SUBJECT: WESTINGHOUSE RESPONSES TO NRC REQUESTS FOR ADDITIONAL
INFORMATION ON THE AP600

NRC REQUEST FOR ADDITIONAL INFORMATION

Re: WCAP-14234 (LOFTRAN CAD)

Re: NOTRUMP PVR FOR OSU TESTS, LTCT-GSR-001, JULY 1995

Figure 4.5-1
Geometry to Which the Horizontally Stratified Flow Link Pair Model
Would Typically be Applied

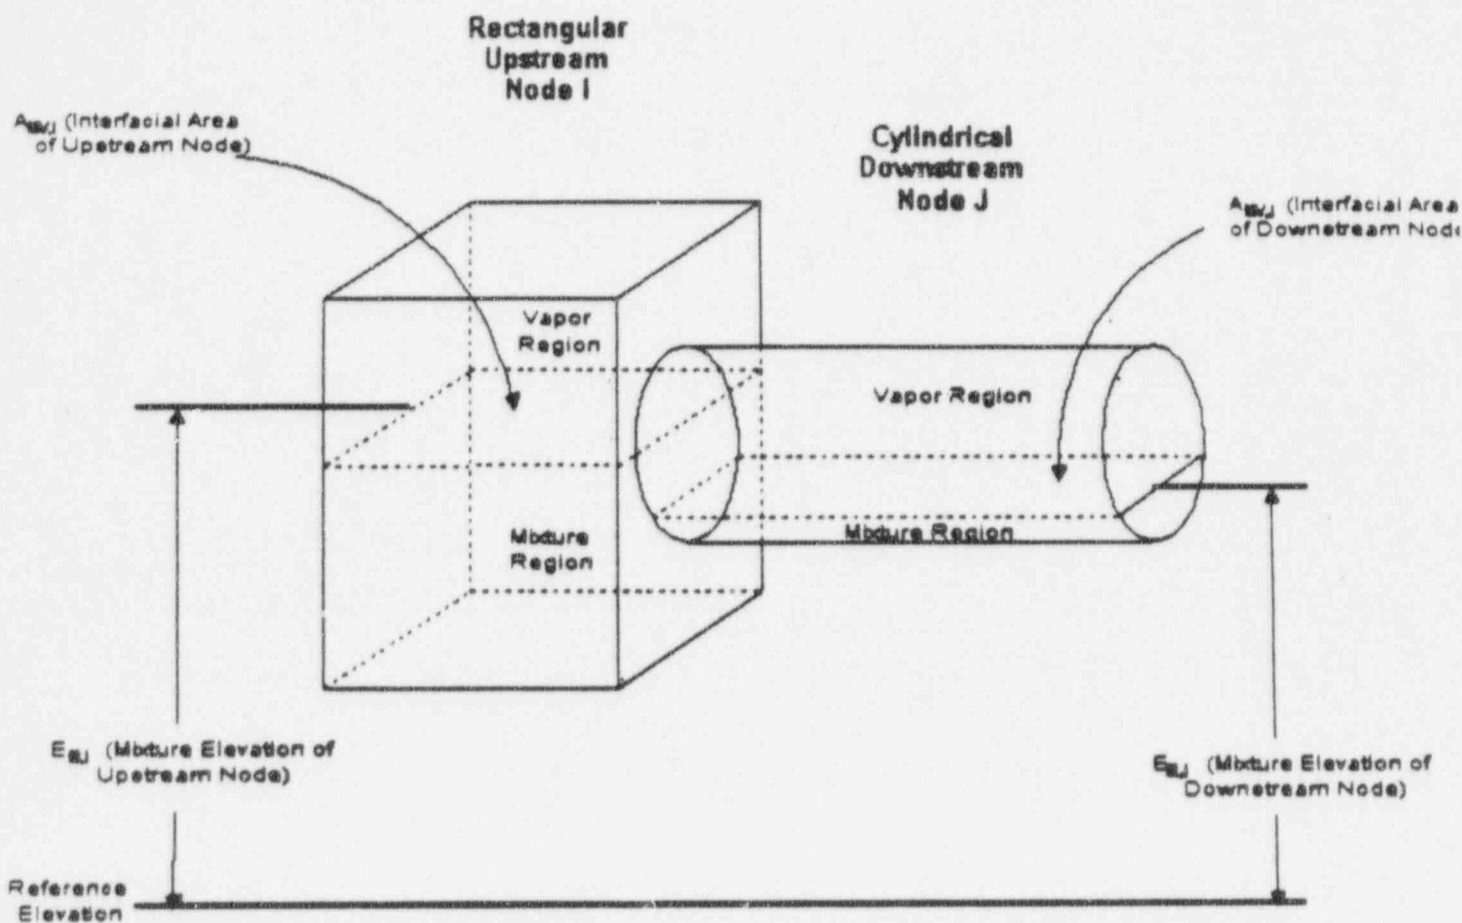
Eq. 4.5-1 describes two terms added to the momentum equation; however, the equation appears to be inconsistent with the volumetric flow based formulation described in Section 4.4 of the report. Please provide the new momentum equation terms in terms of the volumetric formulation. Also describe how the new formulation was validated to justify the modifications. Also clarify if the dW/dt term is to be replaced by the two new terms, and is the plus sign a typographical error in Eq. 4.5-1? Also, show the finite difference form of the new momentum equation and describe how the dA/dt and dp/dt terms are to be computed.

The calculation of the flow component's temporal area derivative involves some geometry. Figure 4.5-1 illustrates a typical situation to which horizontally-stratified flow link pairs are applied. It shows a cylindrical node connected to a rectangular node, and it arbitrarily denotes the rectangular node as the upstream node and the cylindrical node as the downstream node. The figure also shows the mixture elevation in both the rectangular and cylindrical nodes, and the mixture elevation of the rectangular node just happens to fall between the top and bottom of the cylindrical node at an elevation which differs from the mixture elevation of the cylindrical node itself.

In nodes such as the rectangular node of Figure 4.5-1, the interfacial area, A_{MV} , is not a function of the node's mixture elevation. However, in nodes such as the cylindrical node in Figure 4.5-1, the interfacial area is a function of the node's mixture elevation.
